Re: Professional Engineer's Certification of Permanent Control Measure
Flying Horse North Filing No. 3, Pond B

Project: FLYING HORSE NORTH FILING NO. 3

Basin ID: POND B - DESIGN POINT 17 (SW POND ESTATES AREA)

AS-BUILT CONDITION AS OF SEPTEMBER 29, 2026.

DETENTION BASIN STAGE-STORAGE TABLE BUILDER

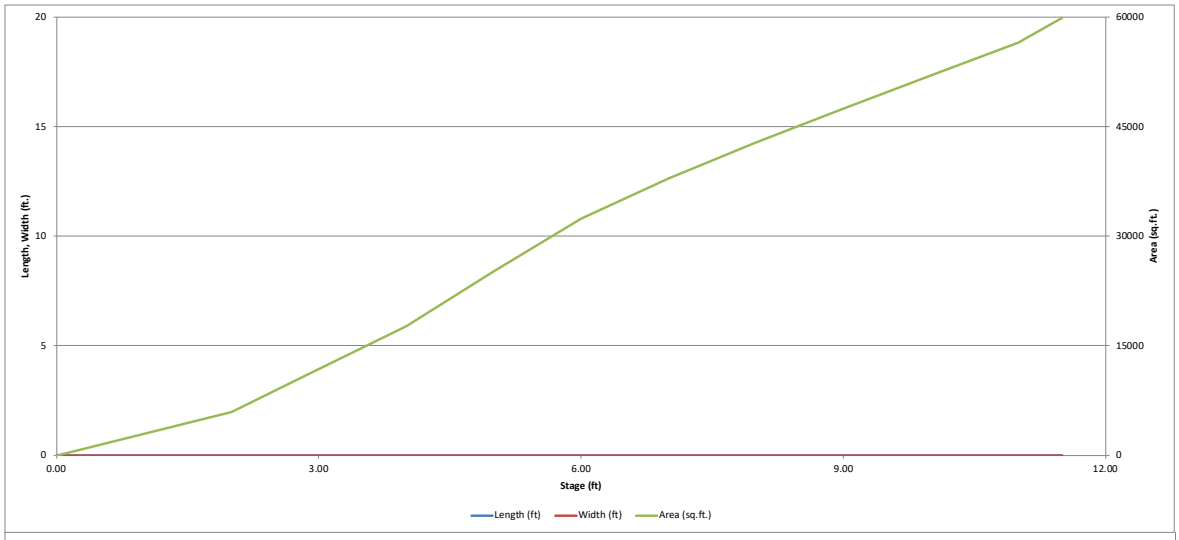
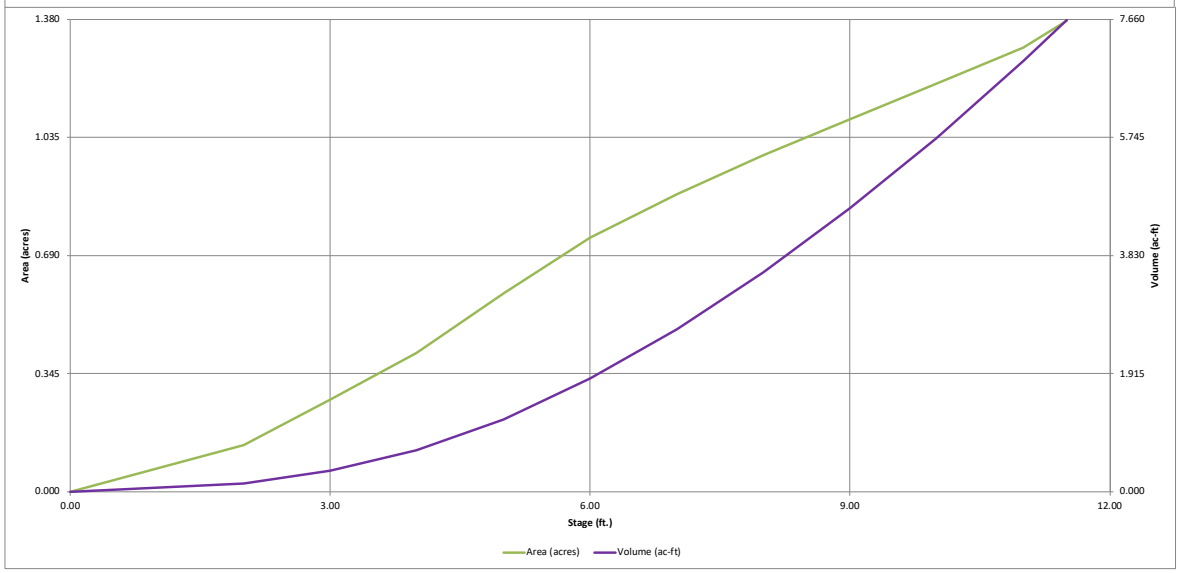
Not sure what happened, but ~50% of the inputs on here do not match what is shown on as-built plans. Please call me if I'm misunderstanding something.

DETENTION BASIN OUTLET STRUCTURE DESIGN

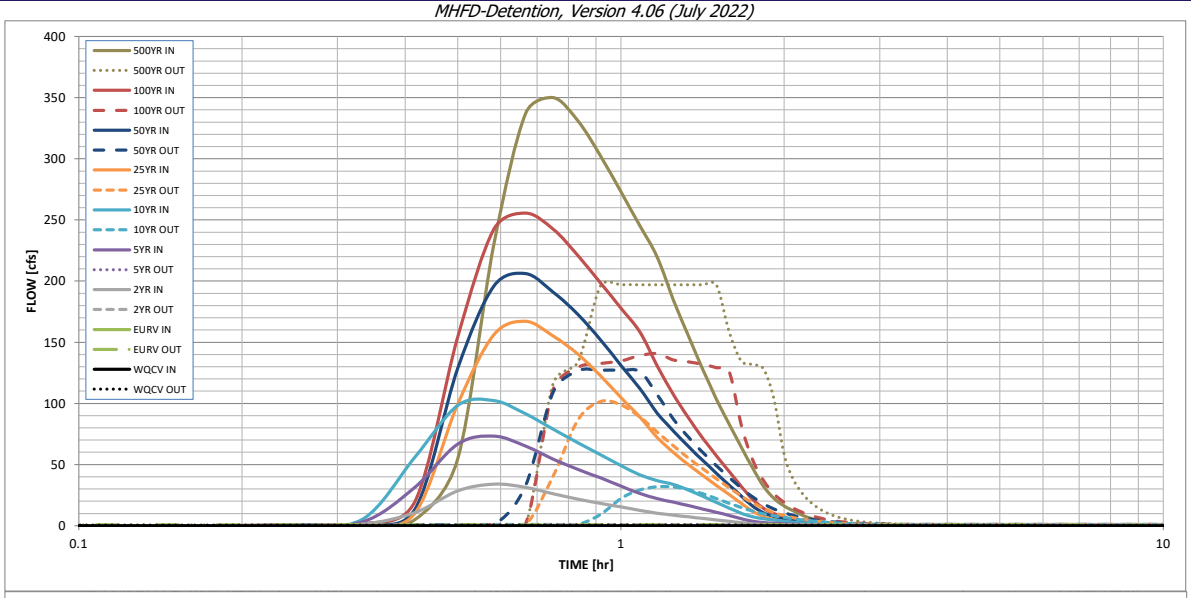
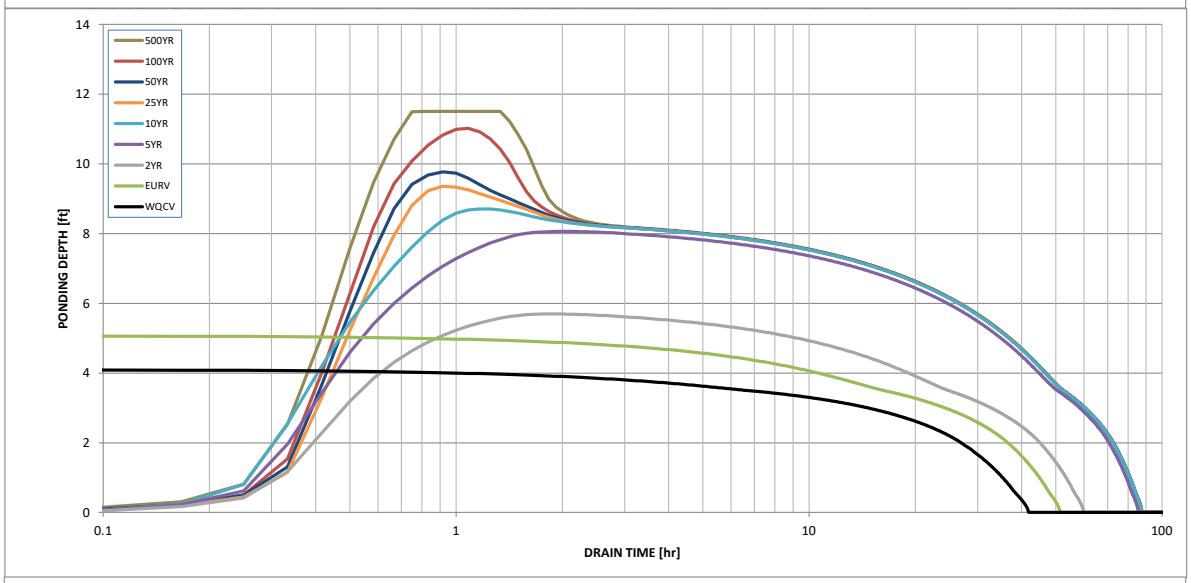
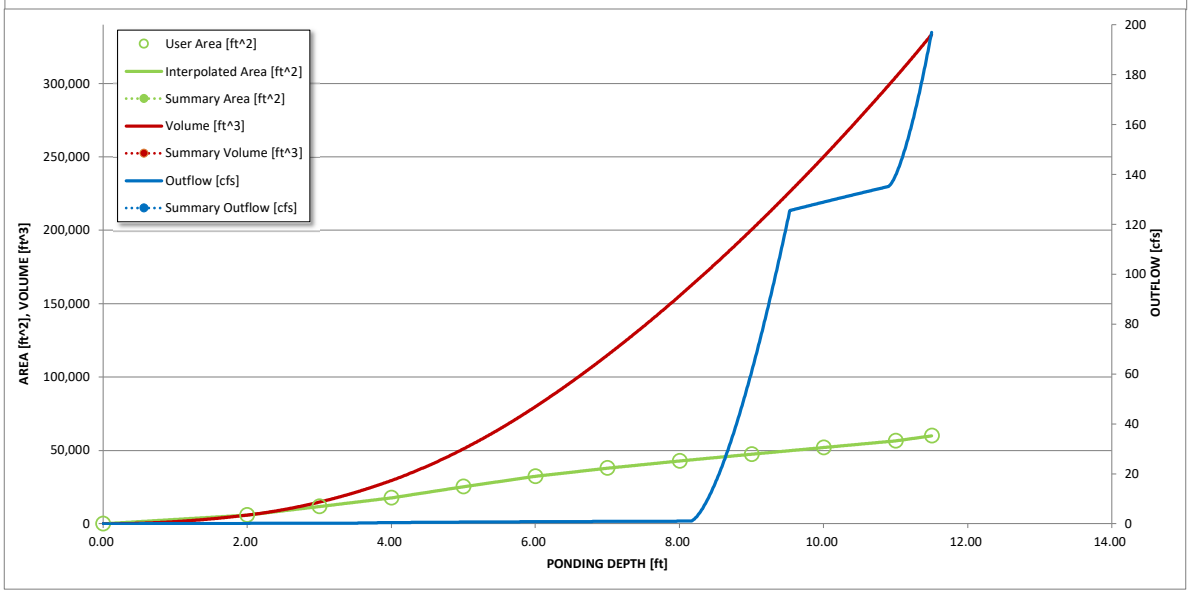
11.5 per plans

11.5 per plans too? Not clear on plans.

REVISED ORIFICE PLATE DESIGN, AS-BUILT 10/6/2026 VERIFIES THIS PLATE DESIGN IS INSTALLED.

RESTRICTOR PLATE ADJUSTMENT VERIFIED IN FIELD 10/6/26.

WITHIN CONSTRUCTION TOLERANCES, APPROVED BY ENGINEER OF RECORD.
